18<sup>th</sup> August 2023

# RE: Car Park Assessment 10 Florida Road, Palm Beach

Figure 1 - Proposed Plan (Source Plans prepared by Peter Princi Architects)

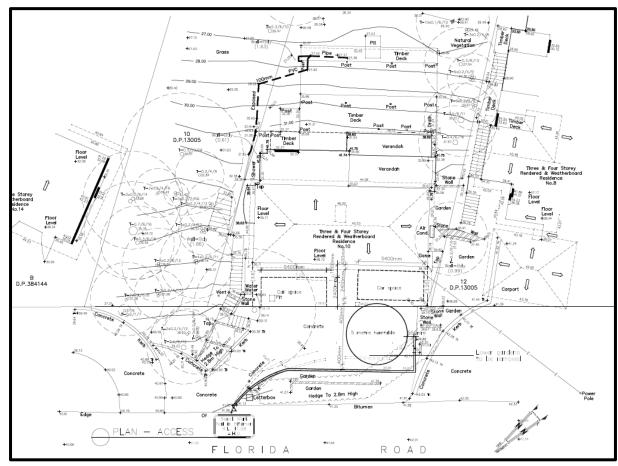
Table 1.1 of AS2890.1 provides a classification of the off-street parking facilities based on various land uses, which is essential in determining the associated parking space dimensions. The proposal involves provision of two car spaces following parallel configuration.

The proposed car spaces were measured to be 2.4m wide, 5.4m long and the aisle width exceeded 3.6m thereby complying with the Australian Standard.

For vehicles exiting the car park, we recommend the area specified in Figure 1 is kept clear of any obstructions.

In relation to the driveway width associated with the Domestic Dwellings Clause 2.6.1 of the AS2890.1-2004 recommends a minimum width of 3.0 metres. The review of the plan indicates the proposed driveway width is in excess to 3.0m and therefore considered compliant.

Figure 2- Minimum Sight Lines for Pedestrian Safety (Source AS2890.1-2204)

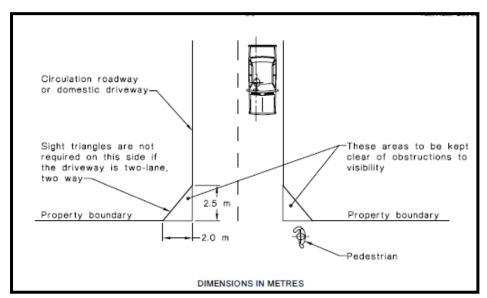
In relation to the pedestrian sight distances Clause 3.2.4 (b) of the Standard stipulates the areas that are required to be kept clear of any obstruction and the figure overleaf indicates this requirement:
